ADDENDUM NO. 2

Rochester City School District

Dr. Walter Cooper, School #10

January 11th, 2019

AD2-H1

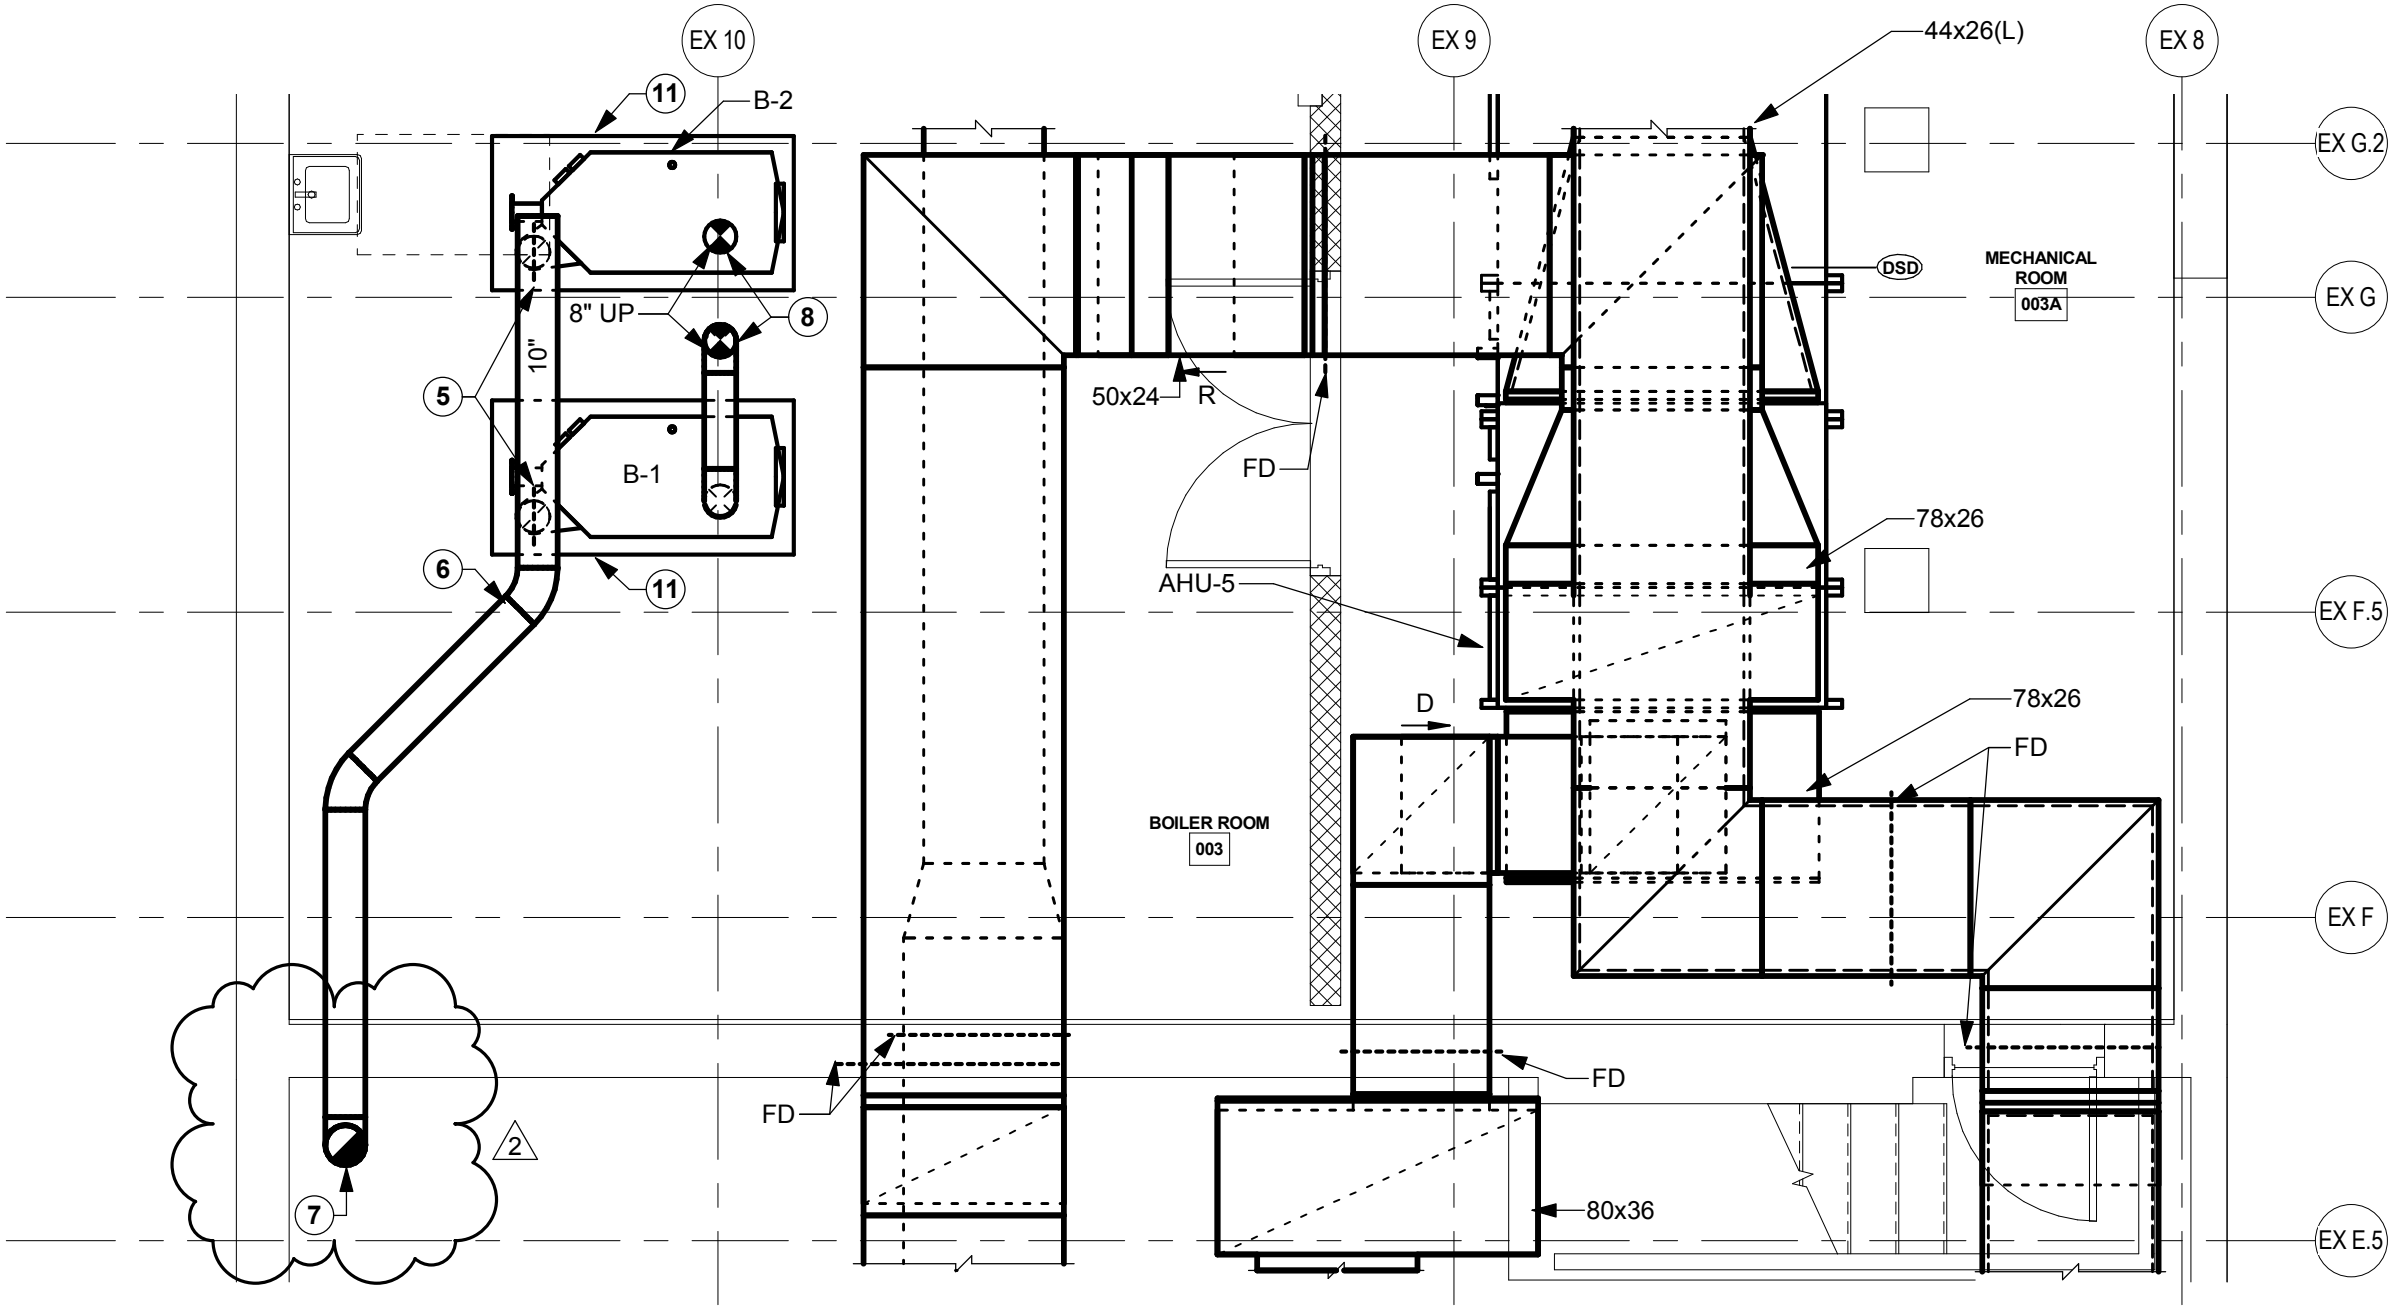
- Item 2-37 **REVISE** note number seven per AD2-H1 (dated 01/11/19).

- 5
- PROVIDE 8" FLUE DAMPER KIT MODEL 100141561 AS MANUFACTURED BY LOCHINVAR AT FLUE OUTLET. PROVIDE INLINE DRAIN ABOVE DAMPER.
- 6
- INSTALL BOILER COMMON VENT PIPING IN ACCORDANCE WITH MANUFACTURER RECOMMENDATIONS. PROVIDE STAINLESS STEEL PIPING MODEL FasNSeal AS MANUFACTURED BY PROTECH SYSTEMS OR EQUIVALENT STAINLESS STEEL VENT APPROVED BY BOILER MANUFACTURER. PITCH FLUE AIR DUCTWORK DOWN TOWARDS BOILERS MINIMUM 1/4" PER FOOT.
- 7
- ROUTE 10" DIAMETER FLUE PIPING UP THROUGH ROOF. PROVIDE DRAIN CONNECTION AT BOTTOM OF T CONNECTION. PROVIDE DRAIN PIPING TO CONDENSATE NEUTRALIZER.
- 8
- ROUTE 8" COMBUSTION AIR PIPING UP THROUGH FLOOR ABOVE AND THROUGH ROOF. PROVIDE GOOSENECK TERMINATION. REFER TO DETAIL.
- 11
- PROVIDE 4" HIGH CONCRETE EQUIPMENT PAD. EQUIPMENT PAD SHALL EXTEND 6" BEYOND THE FOOTPRINT OF THE UNIT ON ALL SIDES.

AD2-H2

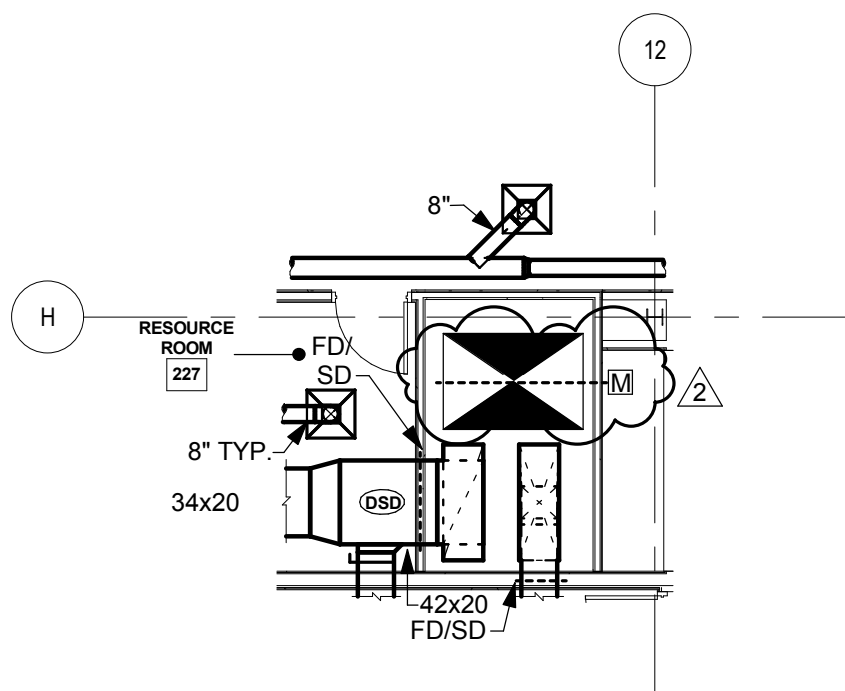
- Item 2-34 **REVISE** 70x48 outside air intake ductwork to include motorized damper at roof penetration per AD2-H2 (dated 01/11/19).
- Item 2-35 **REVISE** 12x10(L) supply air ductwork to include smoke damper and duct smoke detector at corridor smoke door crossing per AD2-H3 (dated 01/11/19).

AD2-H4

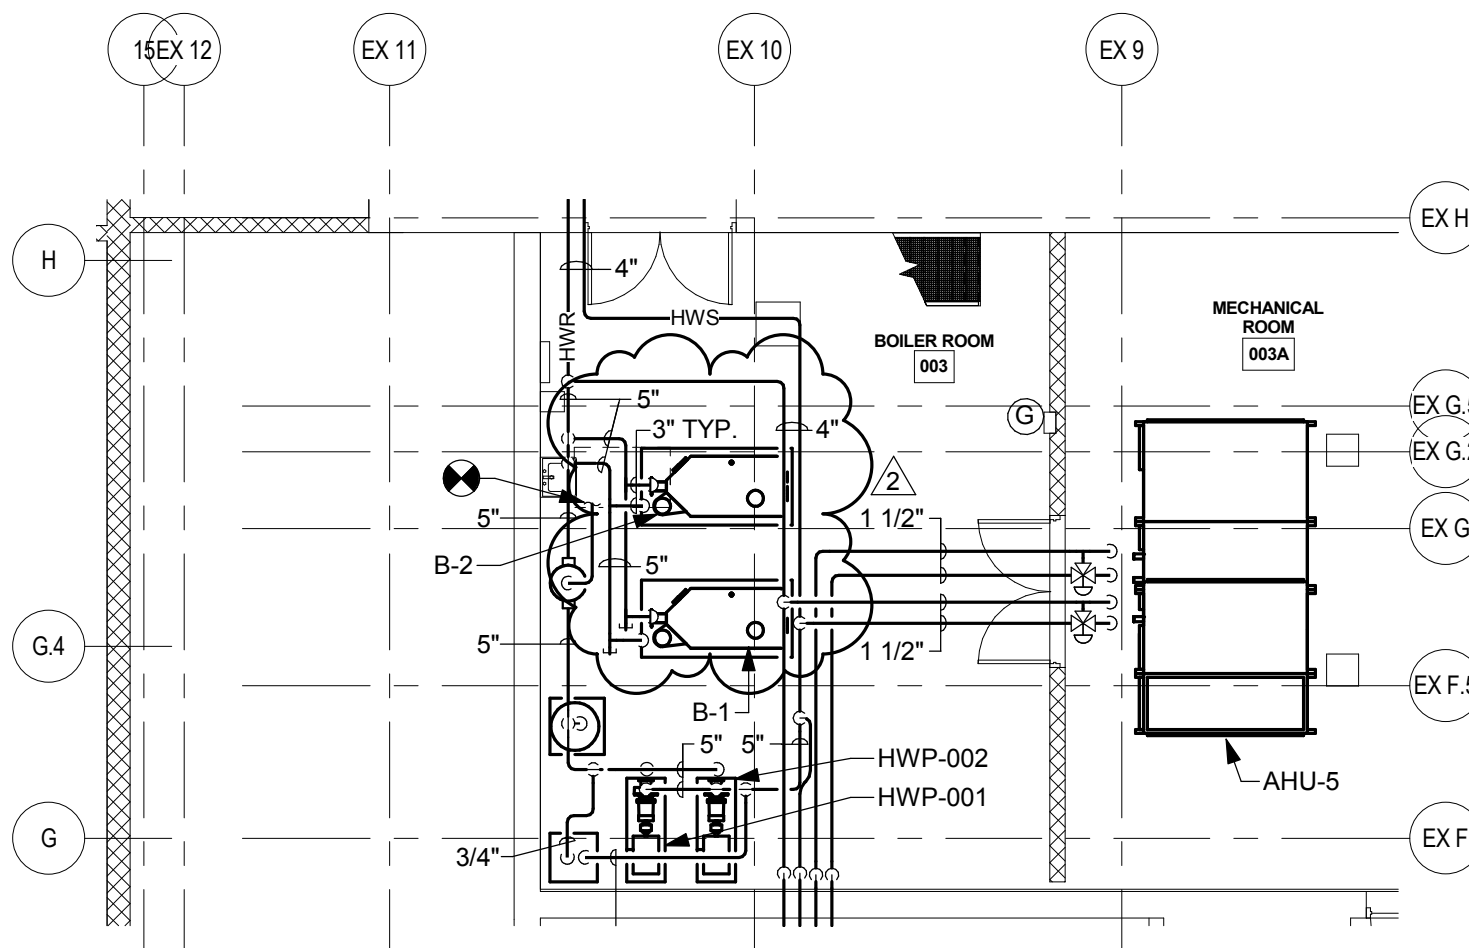
- Item 2-36 **REVISE** boiler piping size to 3" per AD2-H4 (dated 01/11/19).

AD2-E1

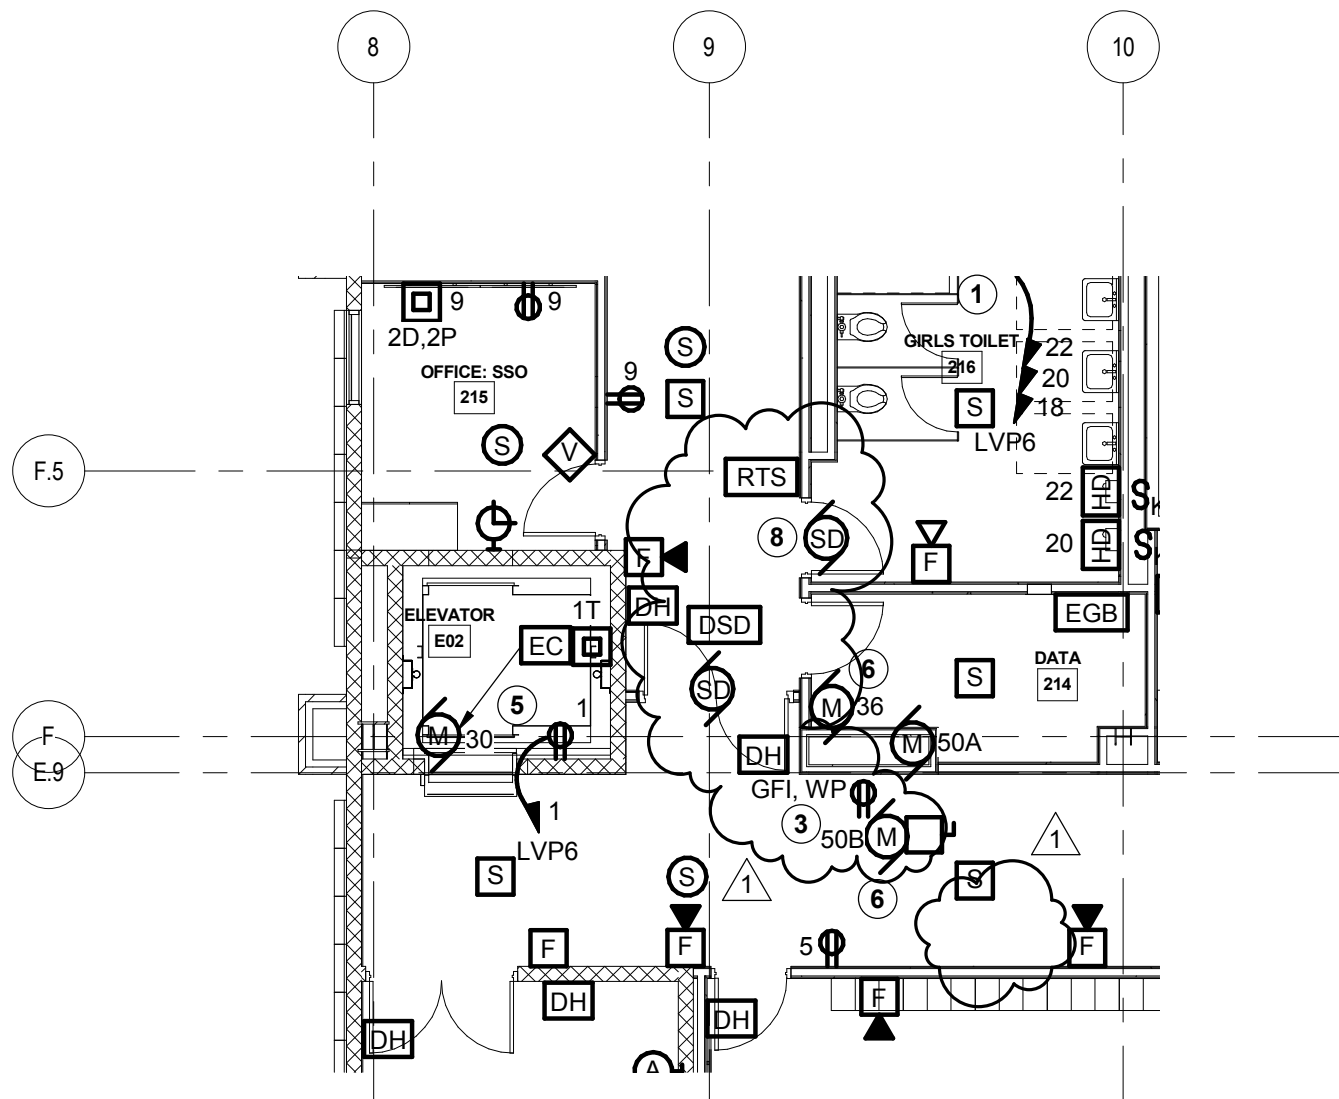
Item 2-40 **REVISE** magnetic door holders, rooftop receptacle, smoke damper, duct smoke detector, and remote test station per AD2-E1 (dated 01/11/19).

AD2-E3

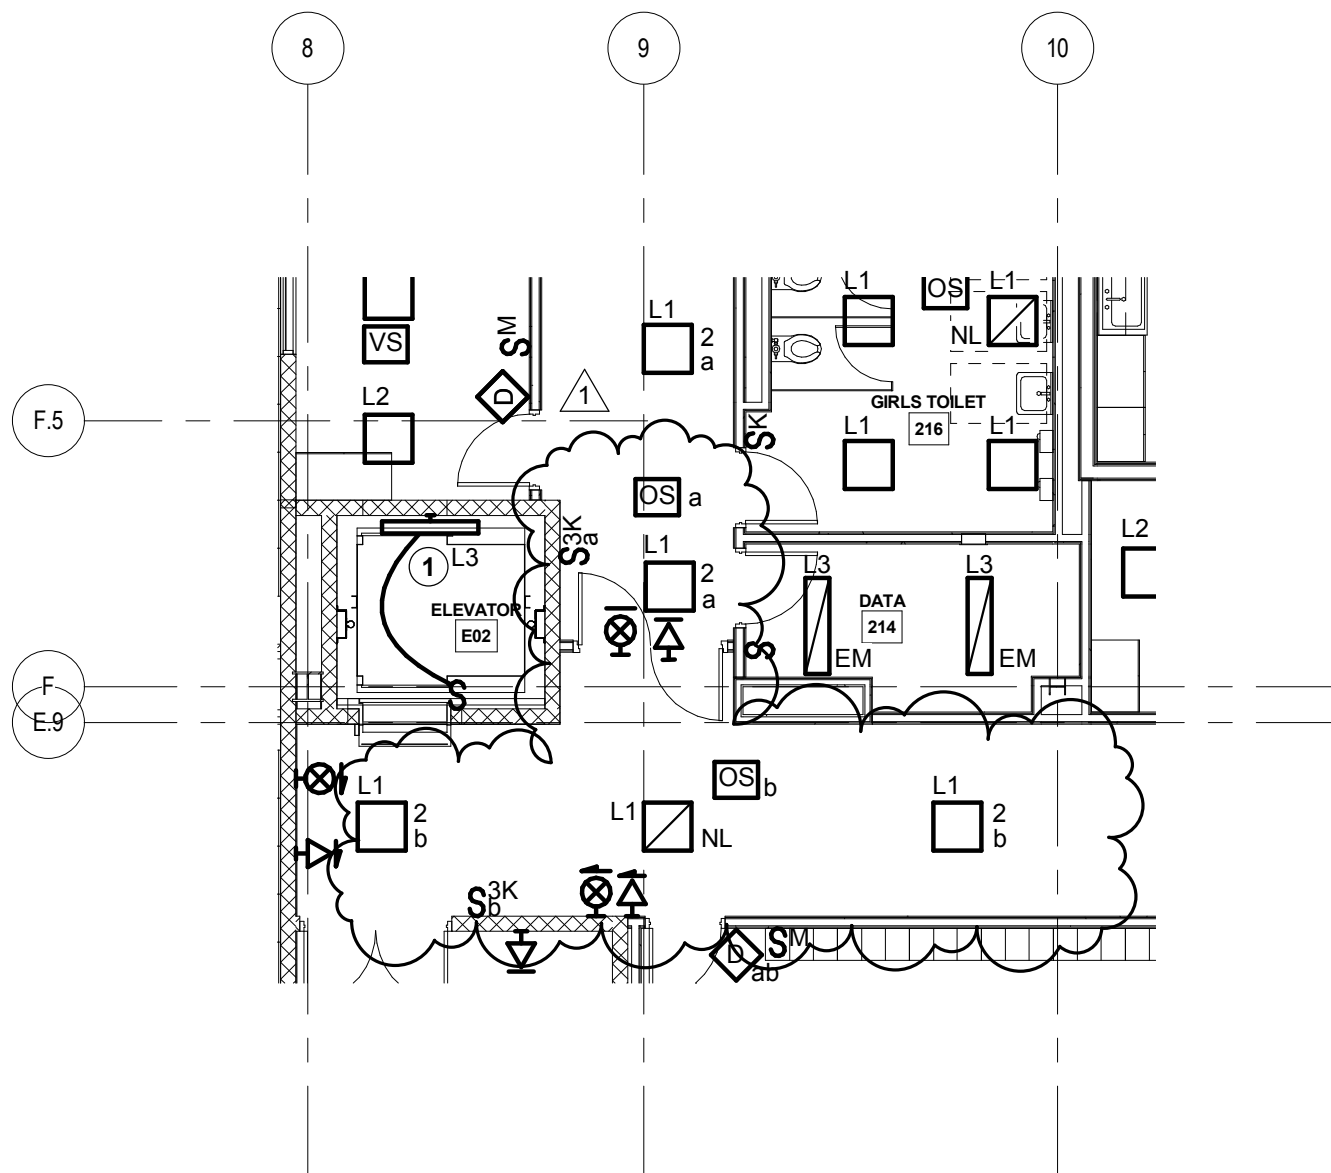
Item 2-1 **REVISE** lighting and light switches per AD2-E3 (dated 01/11/19).

AD2-E4

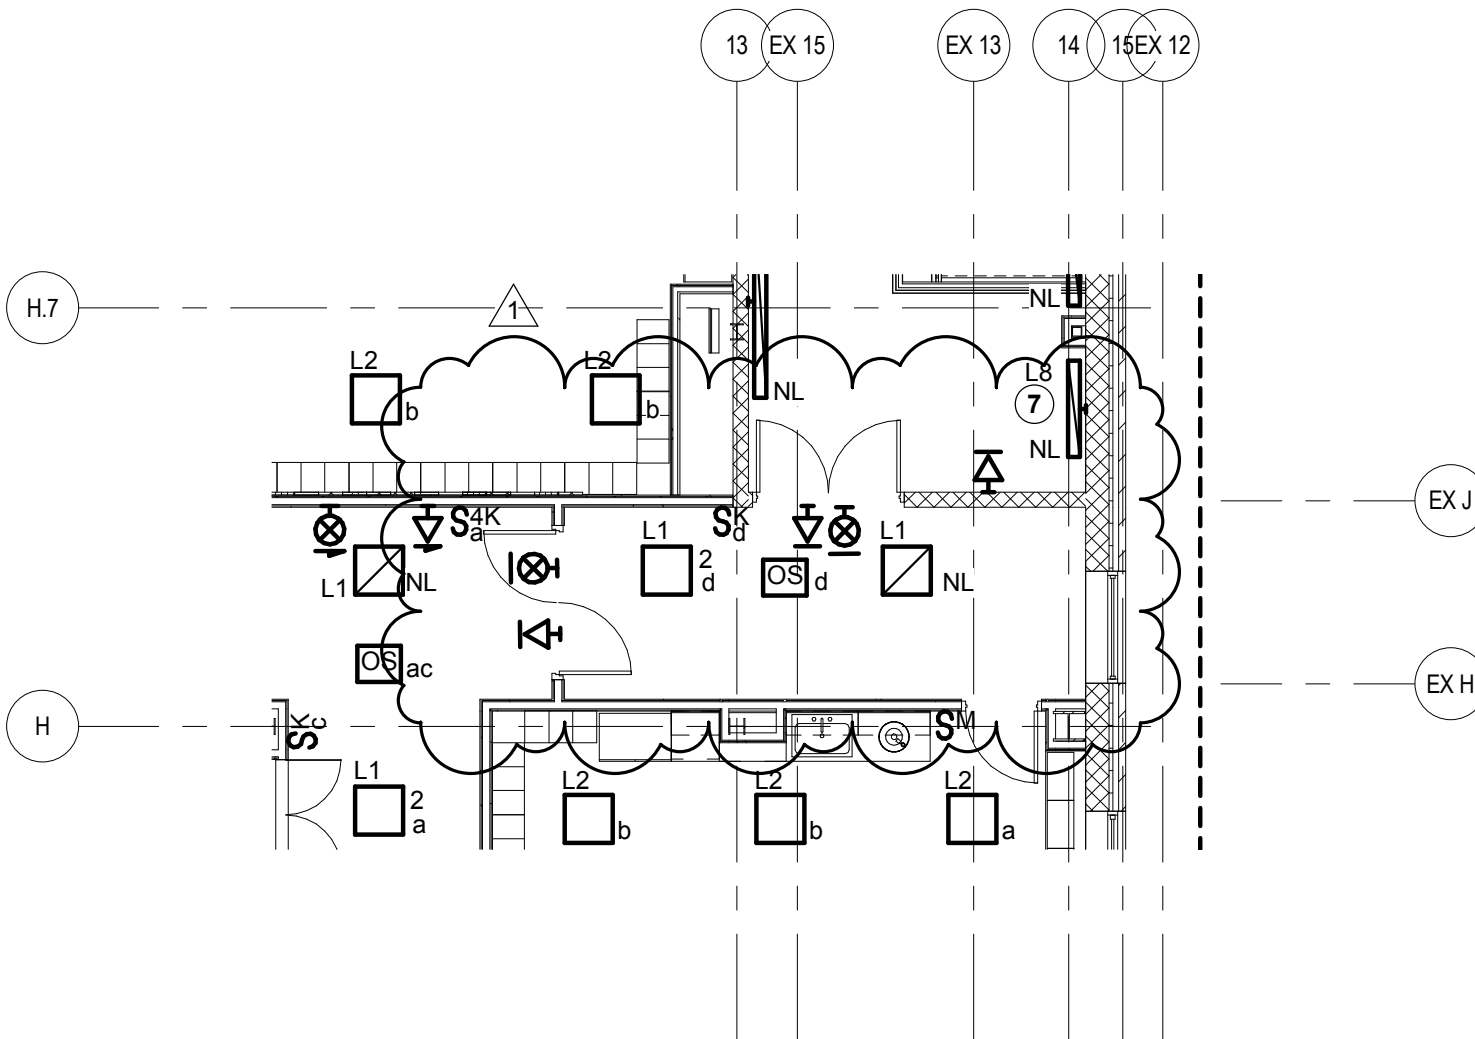
Item 2-2 **REVISE** lighting and light switches per AD2-E4 (dated 01/11/19).
